Accessibility Survey

City of Downey McCallum Street - Marbel Avenue To Cul-de-sac

Date of Inspection
4/2/2017

Prepared By
Disability Access Consultants
(800) 743-7067

Change In Level East Of Tristan Drive @ 33.927315221138, -118.131649196148

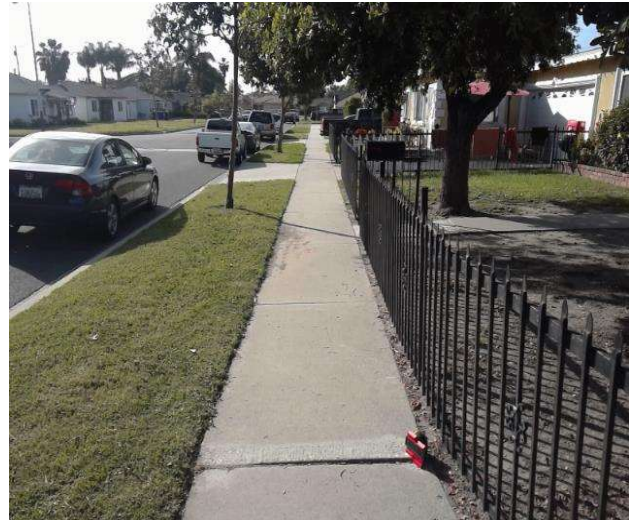
There is a change in elevation greater than recommended value.

On-Site Finding 0.75 inches

Ensure that the change in elevation is within the recommended value.

Recommendation Up to 0.25 inches
